**BOARD MEETING AGENDA**  
**Coon Creek Watershed District Offices - Board Room**  
**Monday, October 28, 2024, 5:30 p.m.**

**Permit Application Review Report**  
**Date: 10/23/2024**

**Project Name:** Elevate Hope Addition

**Project PAN:** P-24-051

Figure 3: Erosion and Sediment Control Plan

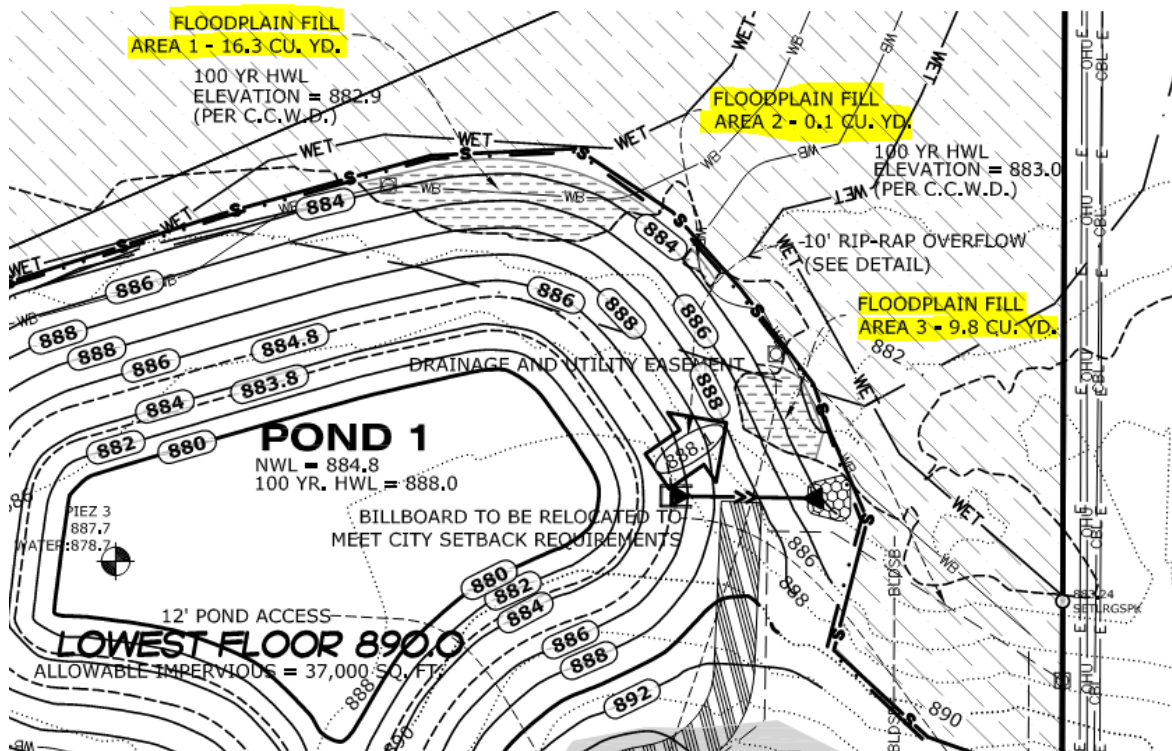
3. Provide a revised erosion control plan that denotes exposed soils and soil stockpiles must be stabilized within 24 hours of inactivity.

The proposed project drains to Coon Creek (Ditch 57). The soils affected by the project include Lino and Zimmerman which have a soil erodibility factor of 0.15 or greater. Disturbed areas are not proposed to be stabilized within 24 hours, as required. The proposed erosion and sediment control plan includes Redundant perimeter control, stabilized construction entrance/exit, and inlet protection. The erosion control plan does not meet District Requirements because exposed soils and soil stockpiles must be stabilized within 24 hours of inactivity. See attached Figure 3: Erosion and Sediment Control Plan

Figure 2: Erosion and Sediment Control Plan

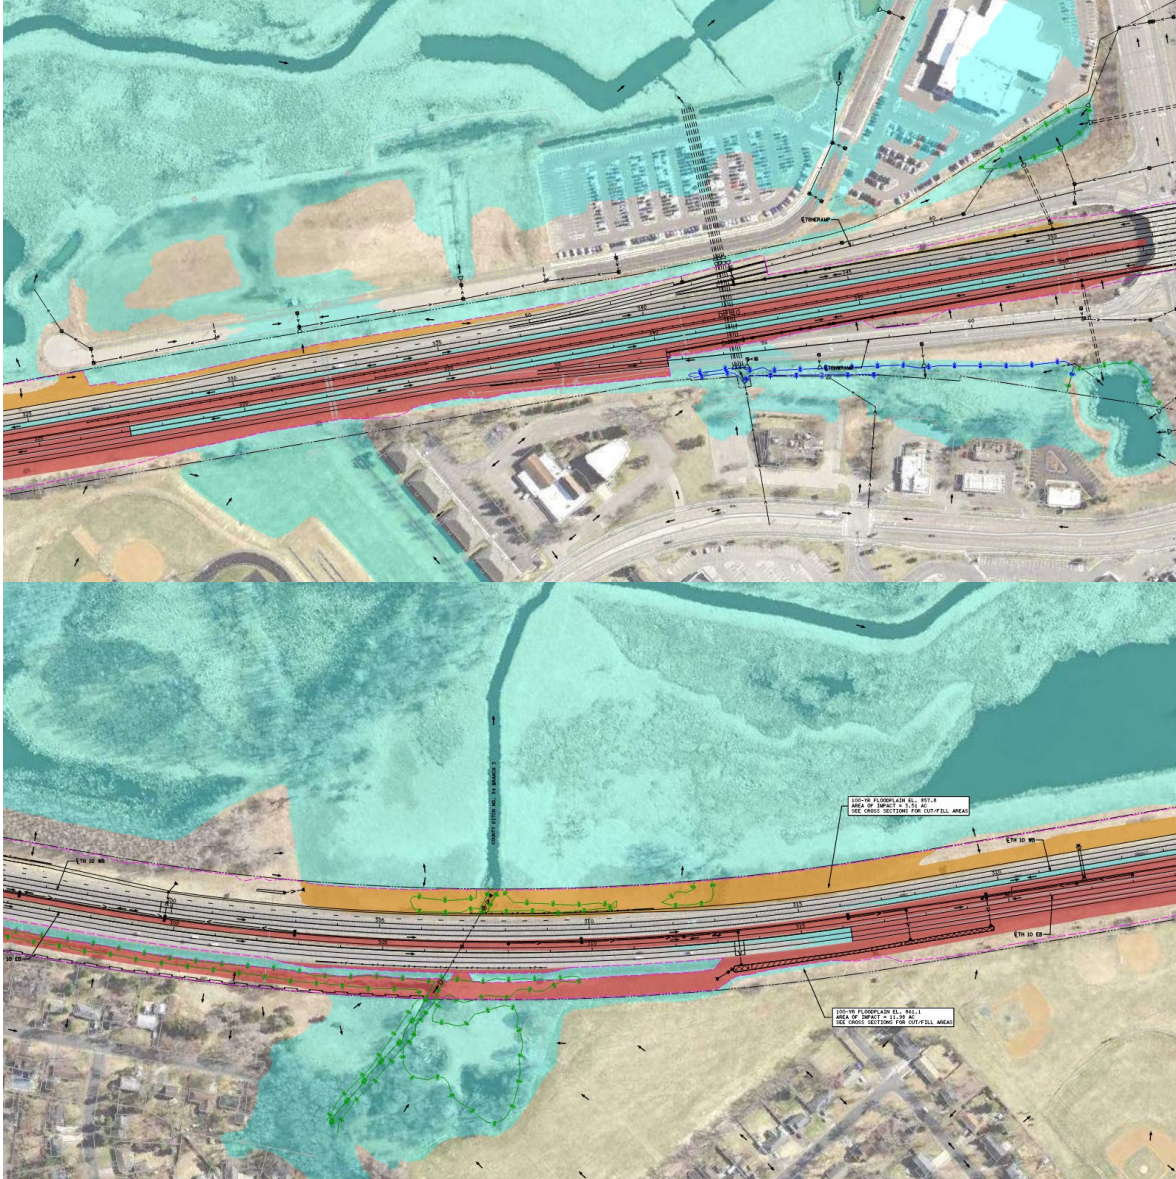
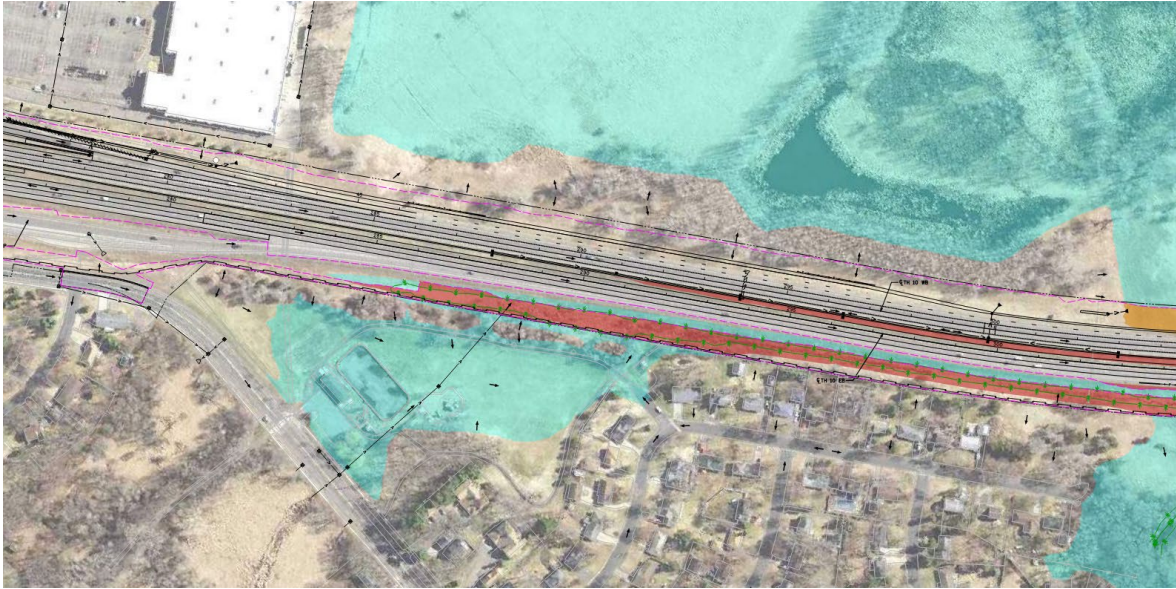
2. Update the erosion and sediment control plan/SWPPP to denote that exposed soils and stockpiles must be stabilized within 24 hours of inactivity.

The proposed project drains to Lower Coon Creek. The soils affected by the project include Nymore which has a soil erodibility factor of 0.15 or greater. Disturbed areas are not proposed to be stabilized within 24 hours, as required. The proposed erosion and sediment control plan includes redundant perimeter control, stabilized construction entrance/exit, inlet protection, provisions for street sweeping, and a stabilization plan. The erosion control plan does not meet District Requirements because the plan does not propose to stabilize disturbed soils within 24 hours. See attached Figure 2: Erosion and Sediment Control Plan

Figure 3: Erosion and Sediment Control Plan

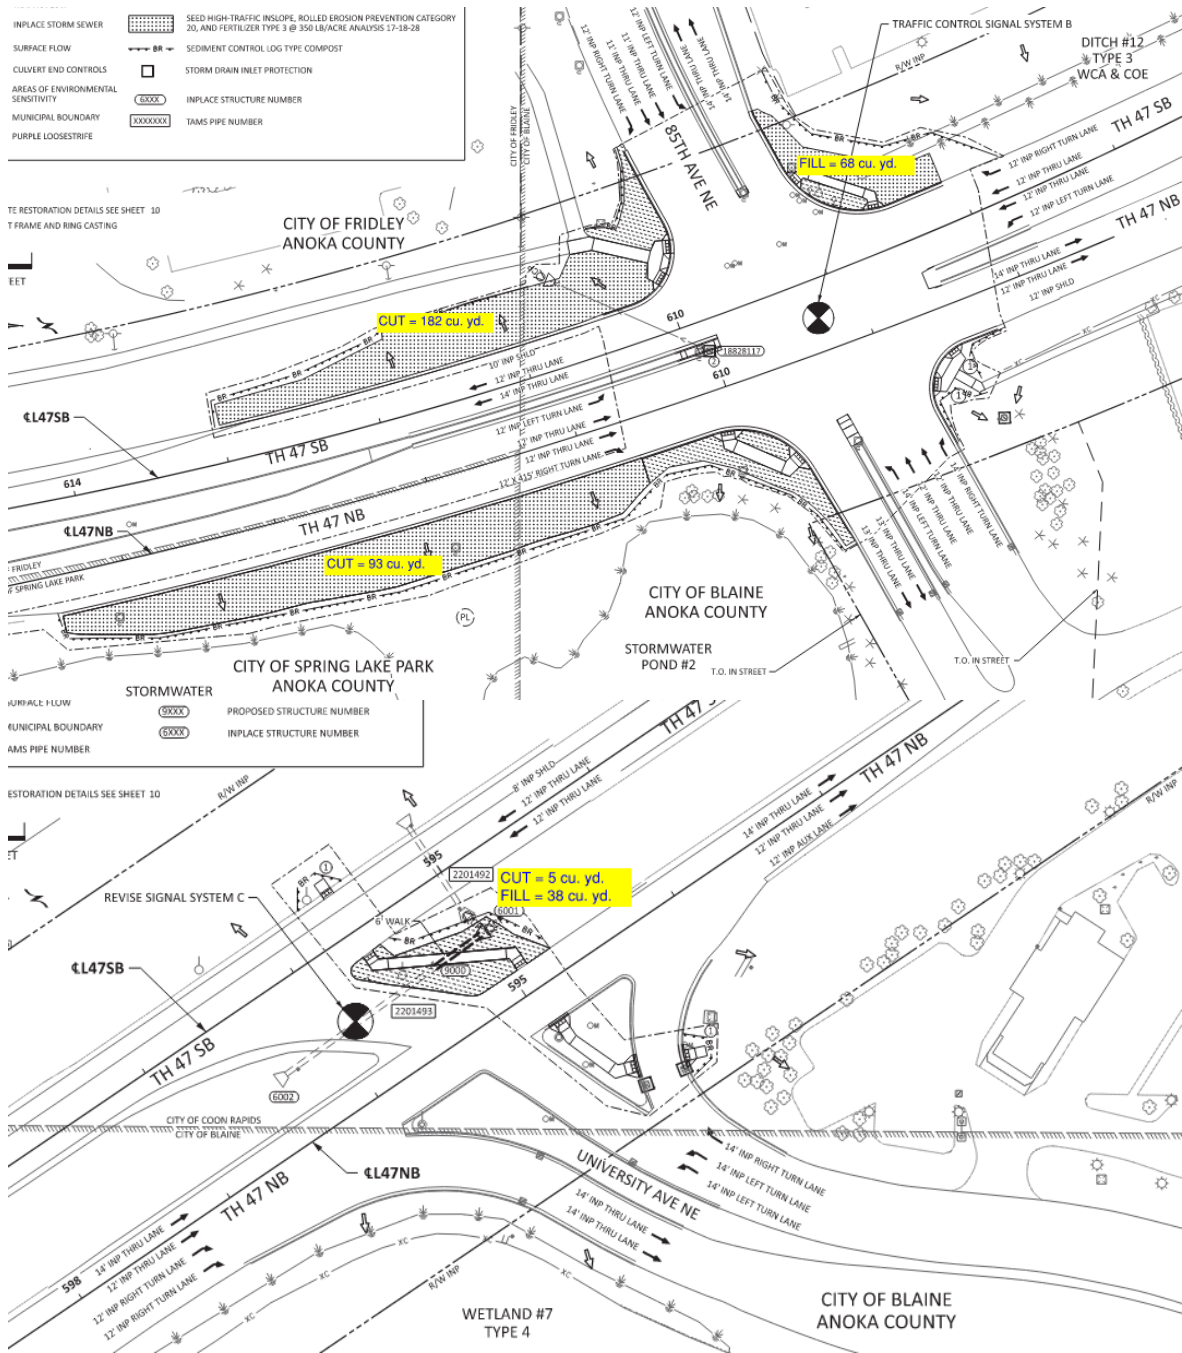
2. Revise the erosion and sediment control plan/SWPPP to denote that exposed soils and soil stockpiles must be stabilized within 24 of inactivity.

The proposed project drains to Springbrook Creek. The soils affected by the project include Zimmerman and Isanti which has a soil erodibility factor of 0.15 or greater. Disturbed areas are not proposed to be stabilized within 24 hours, as required. The proposed erosion and sediment control plan includes perimeter control, inlet protection, street sweeping, and a stabilization plan. The erosion control plan does not meet District Requirements because the plan does not propose disturbed areas to be stabilized within 24 hours. See attached Figure 3: Erosion and Sediment Control Plan.

Figure 3: Erosion and Sediment Control Plan

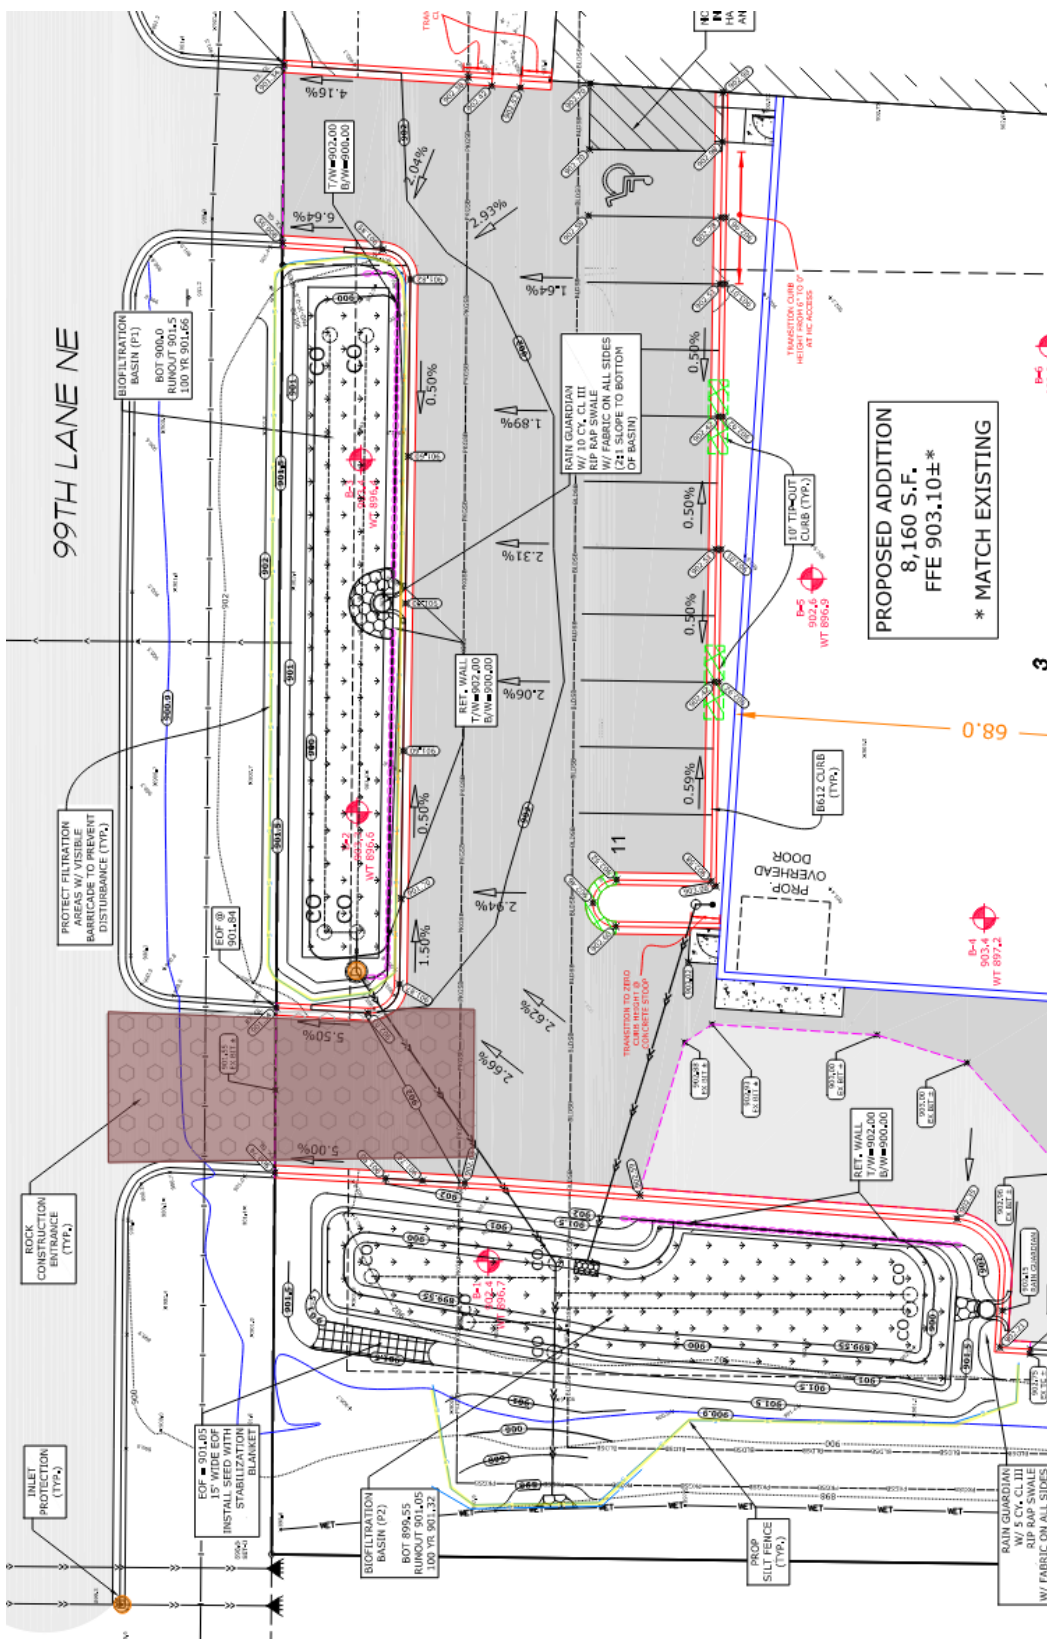
3. Provide an updated erosion and sediment control plan that denotes exposed soils and stockpiles must be stabilized within 24 hours of inactivity.

The proposed project drains to Ditch 41. The soils affected by the project include Isanti which have a soil erodibility factor of 0.15 or greater. Disturbed areas are not proposed to be stabilized within 24 hours, as required. The proposed erosion and sediment control plan includes perimeter control, inlet protection, and a stabilized construction entrance/exit. The erosion control plan does not meet District Requirements because exposed soils and stockpiles must be stabilized within 24 hours of inactivity. The site does not require a NPDES permit. See attached Figure 3: Erosion and Sediment Control Plan
